UNITED STATES PATENT AND TRADEMARK OFFICE

10/522,965

Office Action Summary	Application No.	Applicant(s)	
	10/522,965	GRADU, MIRCEA	
	Examiner	Art Unit	
	David D. Le	3681

DETAILED ACTION

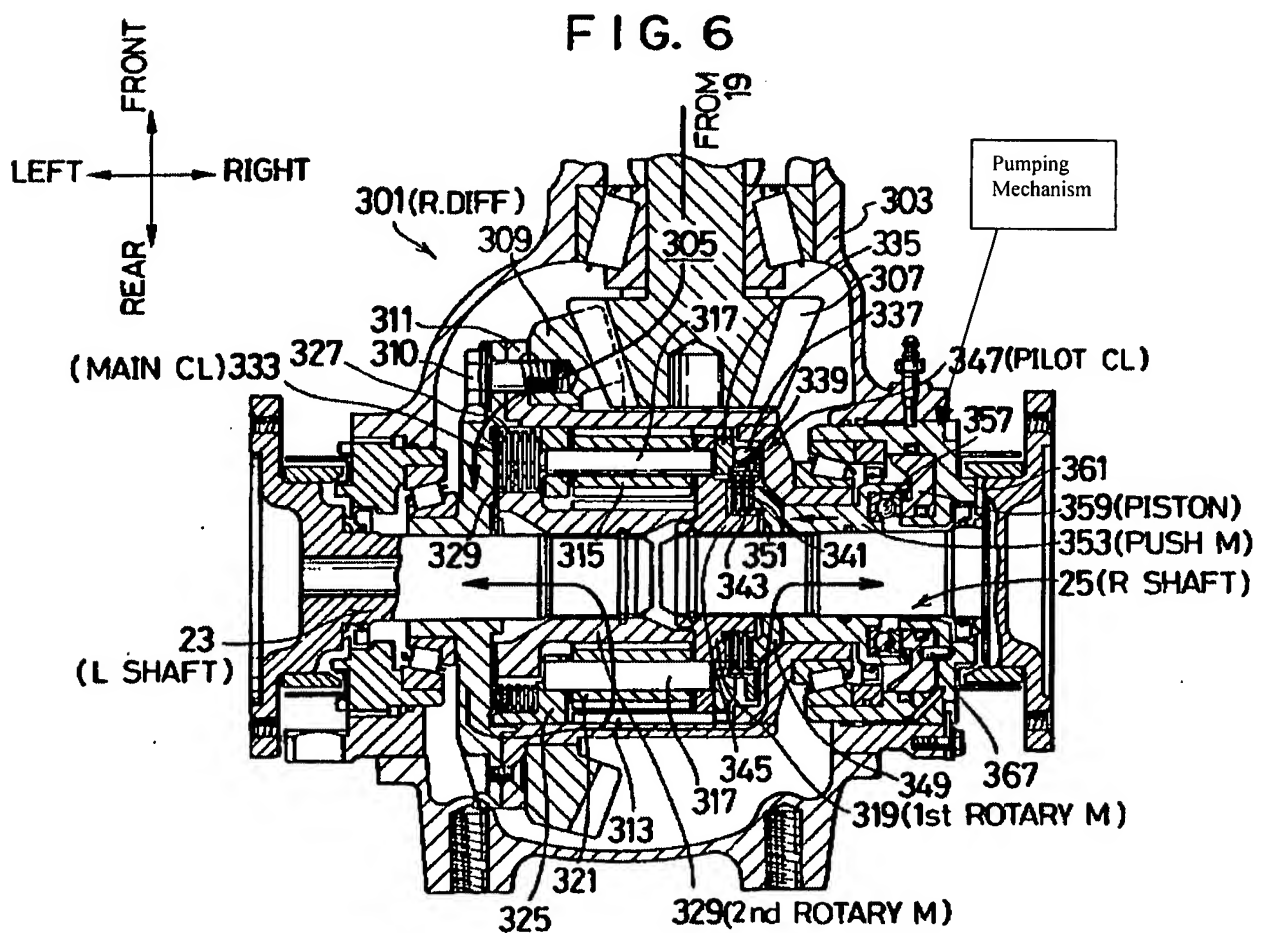
Claims 1-5 and 9-16:

Teraoka (i.e., Figs.2 and 6; column 5, line 54 – column 14, line 9) discloses a differential assembly comprising:

- An input shaft (i.e., Fig. 6, element 311) adapted to be connected to a source of torque (i.e., Fig. 2, element 1 and 3);
- An output shaft (i.e., Fig. 6, element 25) from which torque is delivered, the input shaft (311) and the output shaft (25) having a common axis of rotation (i.e., Fig. 6);

- A clutch (i.e., Fig. 6, element 333) having a first clutch member (i.e., Fig. 6, being the outer friction plates 327) and a second clutch member (i.e., Fig. 6, being the inner friction plates 327) capable of rotating at different angular velocities, the clutch (333) configured for transferring torque between the first and second clutch members when the first and second clutch members rotate at different angular velocities, the first and second clutch member being operatively connected to the input shaft (311);

- A pumping mechanism (i.e. Fig. 6; element Pumping Mechanism above) configured to engage the first and second clutch members of the clutch (333) when the first and second clutch members rotate at different angular velocities;

- A planetary set (i.e., Fig. 6, element 301) including a first element (i.e., Fig. 6, element 313), a second element (i.e., Fig. 6, element 329), a third element (i.e., Fig. 6, element 319), and a fourth element (i.e., Fig. 6, being the combination of elements 315 and 321) organized about the common axis of rotation, the first element (313) operatively connected to the first clutch member and to the input shaft, the second element (329) connected to the second clutch member, the third element (319) connected to the output shaft (25), and the fourth element operatively connected between the first element and the second element, and between the second element and the third element;

- Wherein the input shaft (311), the first element (313), the third element, the fourth element, and the output shaft define a second torque path;
- Wherein the pumping mechanism includes an external gear (i.e., Fig. 6, element 335) operatively coupled to the second clutch member, an internal gear (i.e., Fig. 6, being the right portion of element 313 that engages with element 335) coupled to the input shaft, an axial cam plate (i.e., Fig. 6, element 353), and a piston (i.e., Fig. 6, element 359);

- A locking mechanism (i.e., Fig. 6, element 347) configured to maximize torque transfer between the input shaft and the output shaft;
- Wherein the locking mechanism (347) is disposed in parallel with the clutch (333) between the first and second elements of the planetary set;
